FINAL DRAINAGE LETTER FOR CALM BREEZE FILING NO. 1 EL PASO COUNTY, COLORADO

Please include:
PCD File No. SF2614

Project #08-101

PROPOSED DRAINAGE MAP

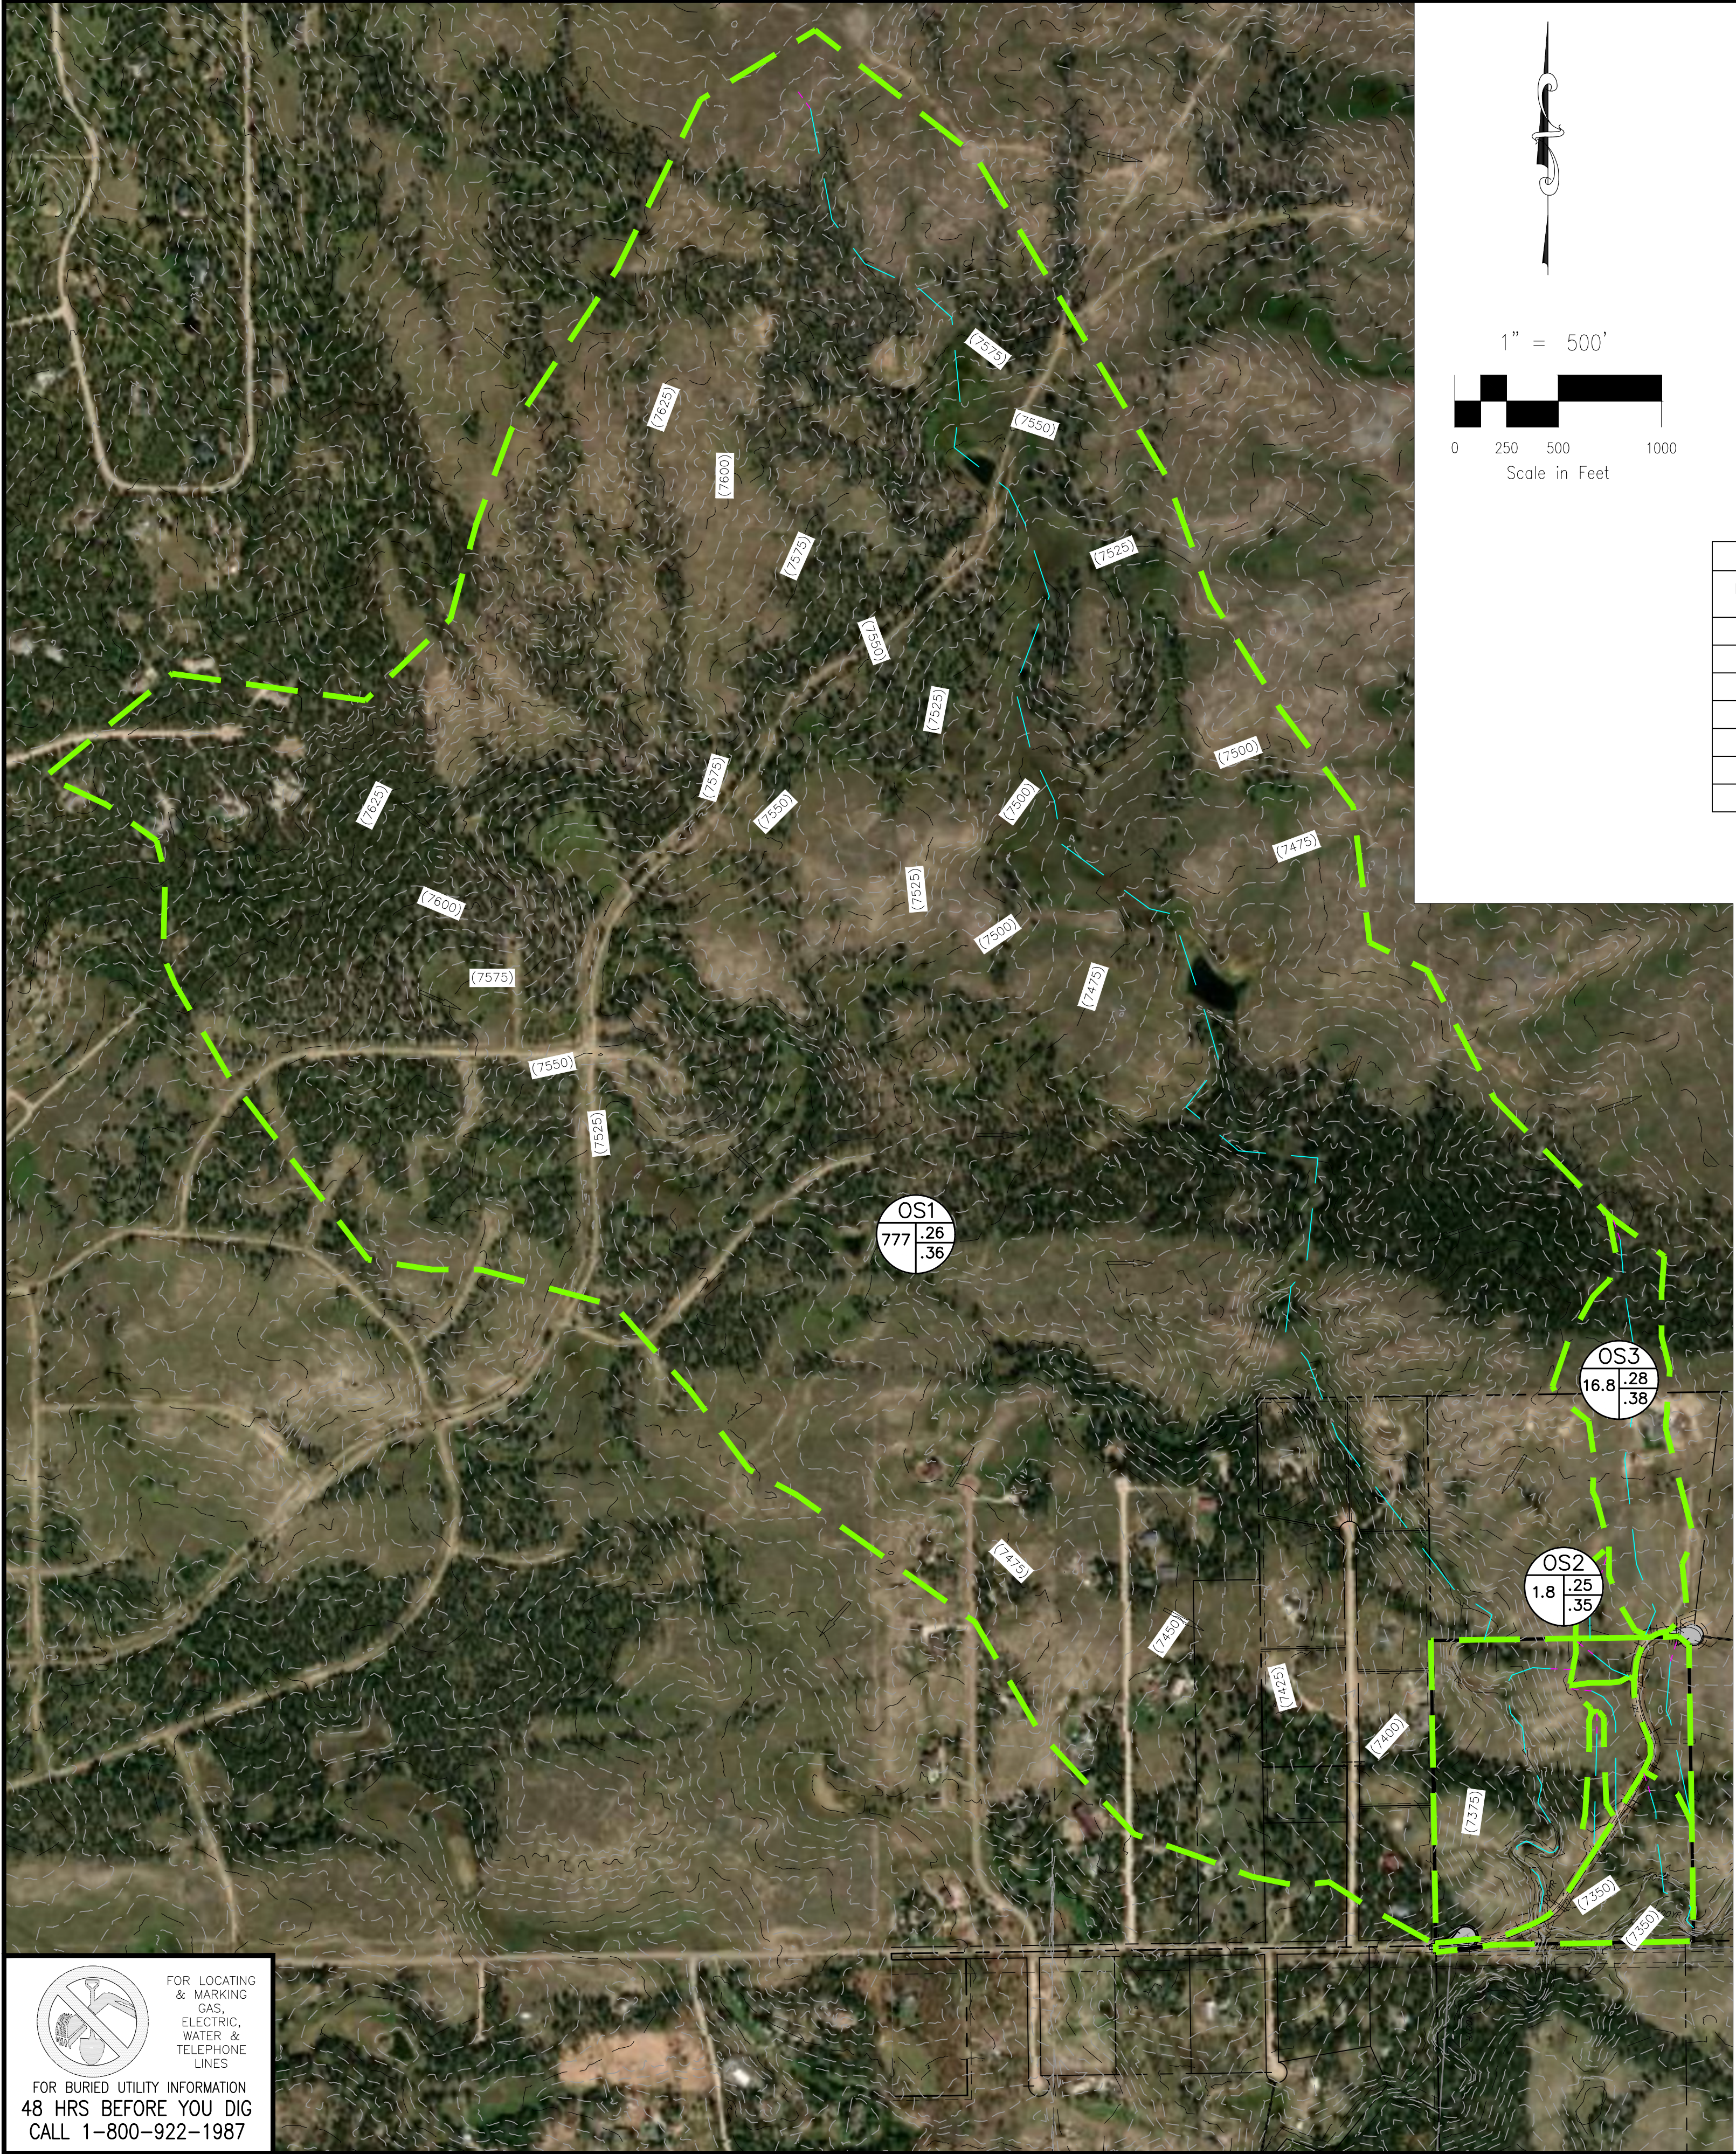
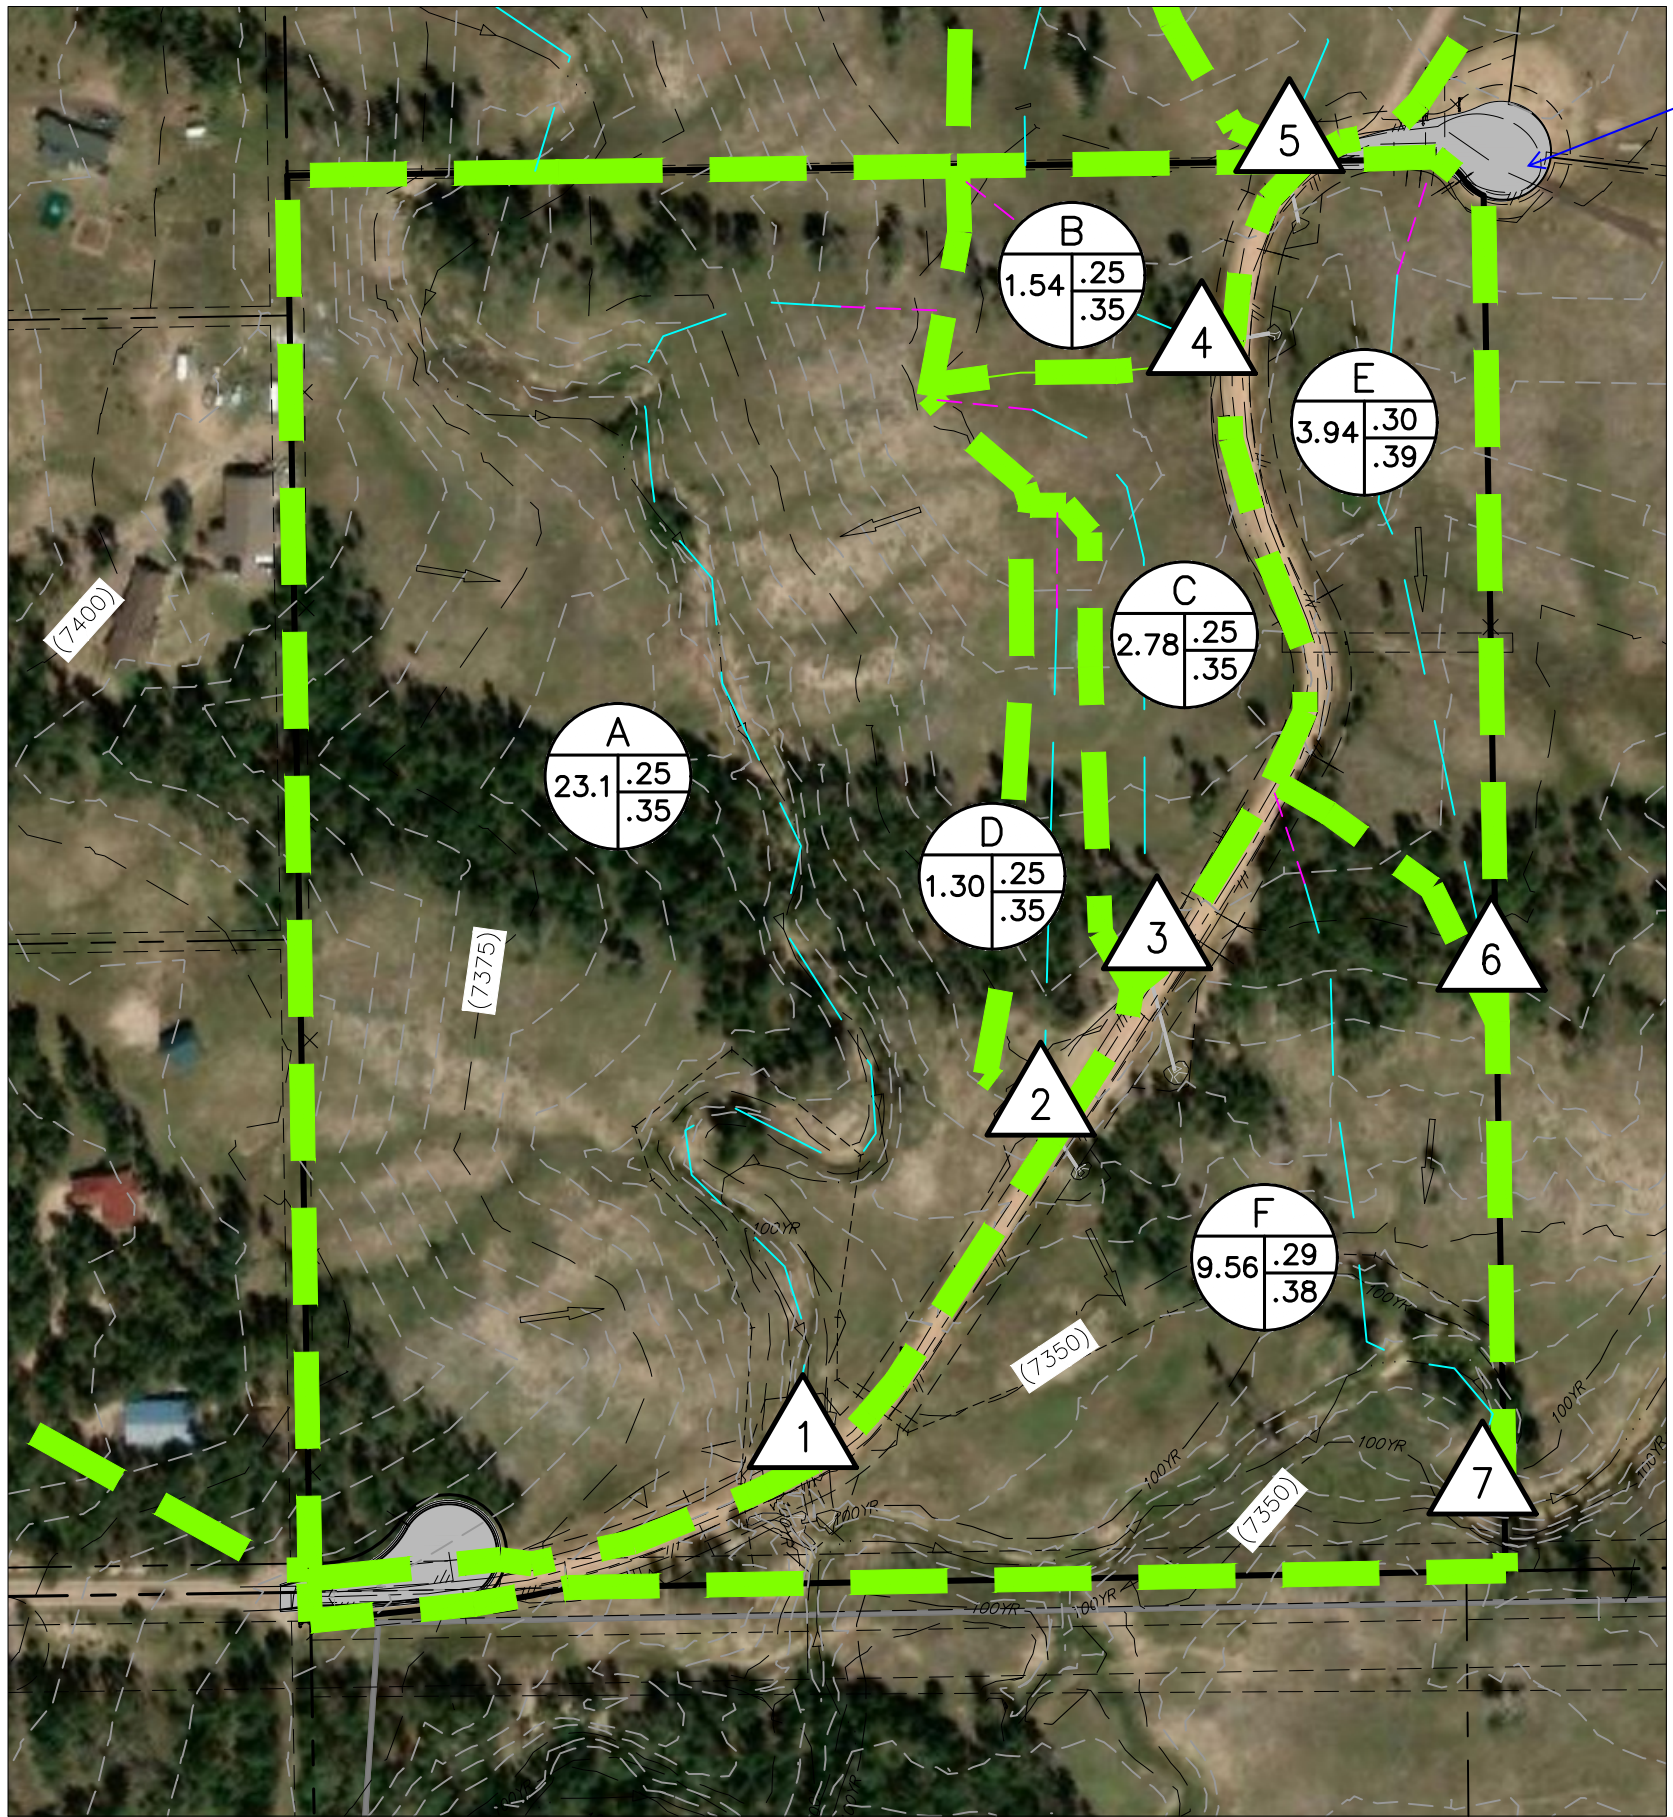
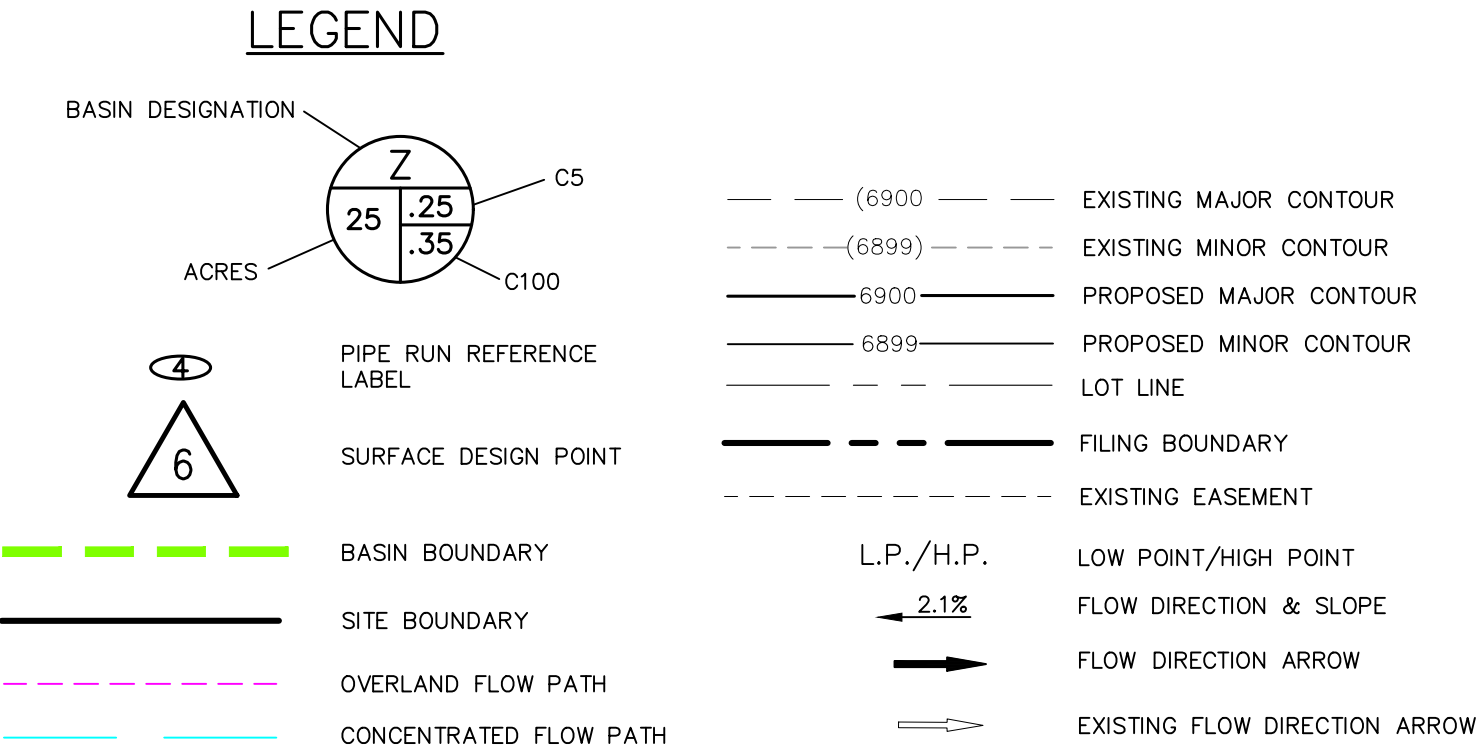
For the proposed condition, assume and show driveways and single family home sites for each of the lots.

Please remove for clarity as there are no proposed improvements here.
